**PLANNED UNIT DEVELOPMENT  
& SUBDIVISION STAFF REPORT****Date: September 7, 2006****DEVELOPMENT NAME**

J. Roe Burton &amp; Old Shell Commercial

Burton Subdivision

3309 Old Shell Road  
(South side of Old Shell Road, 30'+ East of East I-65  
Service Road North, extending to the West side of Sidney  
Phillips Drive)

# SITE PLAN

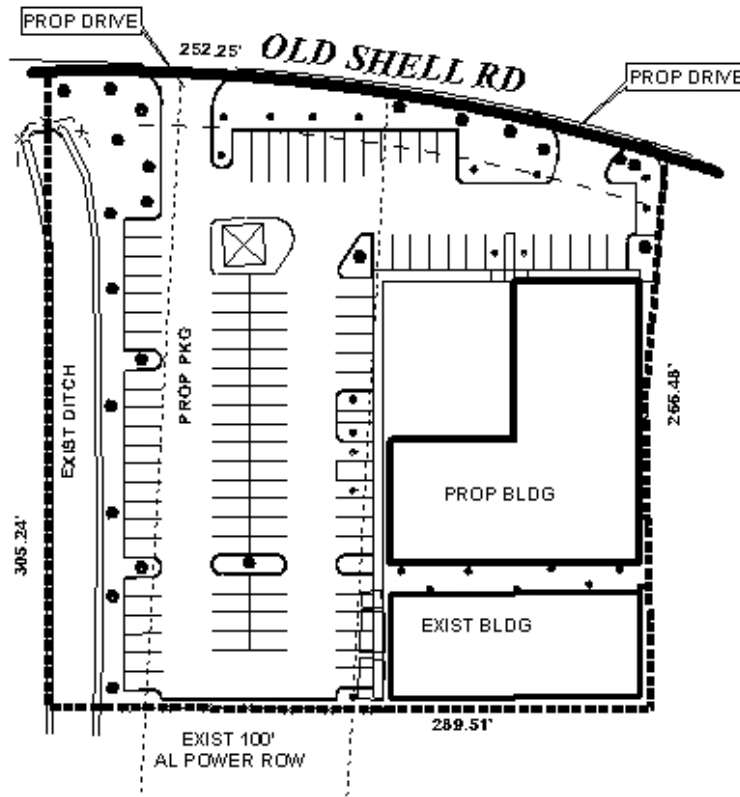
The site is crossed by a 100-foot wide Alabama Power easement with a pylon, and has a 21-foot  $\pm$  wide drainage ditch along the Western property line. These two elements limit the development potential of the site.

The applicant indicates a sidewalk along Old Shell Road. If the existing sidewalk is removed during the construction of the proposed development, a new sidewalk should be provided per the requirements of the Subdivision Regulations. It should be pointed out that the site is within a block of Sidney Phillips Prep School.

Although Old Shell Road is a minor street, access management is a concern. The Subdivision site has sufficient frontage onto Old Shell Road to warrant a maximum of two curb-cuts, however, the proposed PUD development only depicts one curb-cut. A note should be placed on the plat and the site plan stating that the Subdivision site is limited to a maximum of two curb-cuts, with the size, design and location to be approved by Traffic Engineering and conform to AASHTO standards. Should a second curb-cut be desired, the PUD must be amended to depict the second curb-cut.

The proposed 98 space parking area appears to meet minimum requirements, however, several of the corners within the parking lot lack adequate curb radii. The site plan should be revised to ensure that all curb corners within the parking area have adequate radii. It should also be noted that the "Parking Data" box states that 78 parking spaces are provided, while a count of the site shows a total of 98 spaces. The counted number of spaces meets the minimum required by the Zoning Ordinance for office uses, but is not sufficient if food and beverage uses are proposed for the site.

The "Tree Data" box states that 23 overstory trees are provided, while only 22 were counted. The applicant should ensure that an adequate number of trees are provided, in compliance with the tree and landscaping requirements of the Zoning Ordinance. The landscaped area located along the East side of the newly created lot should include curbing to protect the area from vehicles maneuvering within the adjacent lot. The transition from the curb along the Eastern edge into the parking area on the site should be smooth, per prevailing parking area design standards.

It appears that development of the site as proposed may require compliance with the City's storm water and flood control ordinances. As such, the provision of a stormwater detention area may be required. The Engineering Department should be consulted, and if a detention area is required, the site plan should be revised to depict the required detention area.

Finally, there is no indication on the site plan as to the proposed location of any dumpster or other waste storage facility. The location of the storage area for the dumpster must be indicated on the site plan, and the location and required screening must comply Section 64-4.D.9. of the Zoning Ordinance, as well as with all other applicable regulations.

*Calculation of the identified landscape areas indicates that there may be a discrepancy between what is depicted and what is listed in the "Landscaping Data" table. It appears, however, that the applicant is exceeding the minimum landscape area requirements.*

*The applicant has submitted a revised site plan that eliminates access to the easement to the East, adds a second curb-cut to Old Shell Road, and increases parking to 103 spaces. The revised site plan addresses most of the concerns identified by staff.*
